Office Action Summary

10/579,877

DUNKER ET AL.

DETAILED ACTION

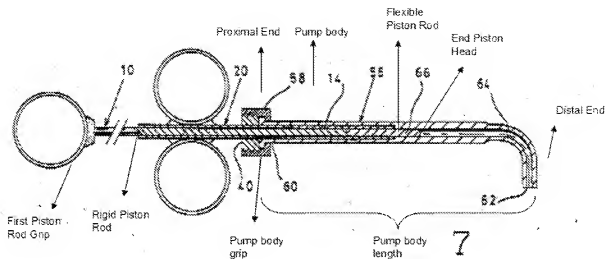
Regarding **Claim 15**, Schmitz discloses an injection pump for application of highly viscous media that have to be applied with pressure during percutaneous vertebroplasty comprising:

(a) a pump body having a pump body proximal end, a pump body distal end, and a pump body length (as seen in Fig below);

(b) a pump body grip fastened at said pump body proximal end (as seen in Fig below); and

(c) a piston system comprising a rigid first piston rod having a first piston rod proximal end and a first piston rod distal end, a flexible second piston rod connected to said first piston rod at said first piston rod distal end and having a second piston rod distal end, a first piston rod grip connected to said first piston rod at said first piston rod proximal end, and an end piston head at the second piston rod distal end for taking up bone cement; wherein said end piston head is movable along the entire pump body length between the pump body distal end and the pump body proximal end (as seen in Fig below where there is a first rigid piston rod connected to a flexible second piston rod and an end piston head moveable along the length).

Regarding **Claim 3**, Schmitz discloses the pump body comprises a ductile plastic material (see Col 1 lines 65-67).

Regarding **Claim 4**, Schmitz discloses the pump body has a rigidly bent shape (as seen in Fig above and see Col 2 lines 42-44).

Regarding **Claim 5**, Schmitz discloses the flexible second piston rod conforms to the rigidly bent shape of the pump body (as seen in Fig above and Col 2 lines 39-41 where the second piston rod is flexible and can conform to the bent shape).

Regarding **Claim 7**, Schmitz discloses the second piston rod is fitted with a flexible material (see Col 2 lines 39-41).

Regarding **Claim 14**, Schmitz discloses the pump body is arranged at the pump body grip and is firmly rotatable and replaceable (as seen in Fig above in Claim 15 where it is rotatable and replaceable if one chooses to do so).

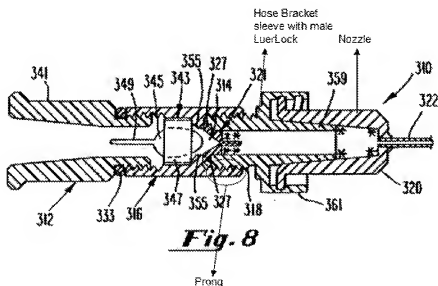
However, Baldwin discloses a similar injection pump with an end piston head with a centered venting boring with a rear section equipped with an air-permeable filter, wherein the centered venting boring has a vertical boring which is radially covered with a valve hose (as seen in Fig below), where it allows for passage of air but is impervious to fluids (See Col 4 lines 6-18).

It would have been obvious to one having ordinary skill in the art at the time the invention was made to modify the combination of Shmitz and Fischione to include the filter and venting boring and valve hose in view of Baidwan as taught above because it allows for passage of air but is impervious to fluids.

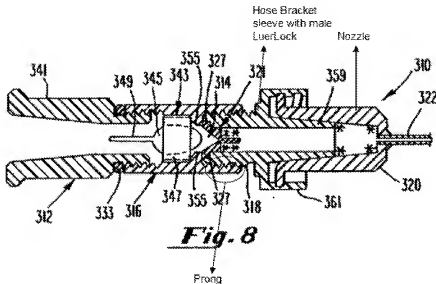
However, Shmitz discloses a similar device where the injection pump (#10) with a bend (as seen in Figs 1-2), a flexible rod (#12) with a Luerlock (#36) for attachment with a nozzle (#30 and see Col 2 lines 54-61) in order to introduce it with filler material (see Col 3 lines 40-60). Century discloses disclose a hose bracket sleeve with an attached rotatable male LuerLock at the distal end of the pump body, wherein a nozzle is screwed to the rotatable male LuerLock to take up highly viscous media from a respective vessel which nozzle can be unscrewed after absorption of such highly viscous media, wherein the male LuerLock is fitted with a prong to fasten the pump body by radially pressure-forcing the pump body into place (see figs below and Col 10 lines 59-65, Col 11 lines 4-24, which teaches a standard male LuerLock to connect with a nozzle, where the LuerLock is attached to the body and is rotatable with prongs that

help keep the LuerLock in place, which also exerts force on the body).

It would have been obvious to one having ordinary skill in the art at the time the invention was made to modify the device of Clark to include the Luerlock and attachment in view of Shmitz because it applies a known technique to a known device ready for improvement to yield predictable results of introducing filler material for displacement. It would also have been obvious to one having ordinary skill in the art at the time the invention was made to modify the combination of Clark and Shmitz to include the the rotatable male LuerLock connection and prongs in view of Century because it applies a known technique to a known device ready for improvement to yield predictable results of fastening a nozzle against an injection device through radially pressure-forcing to hole the pump body into place.
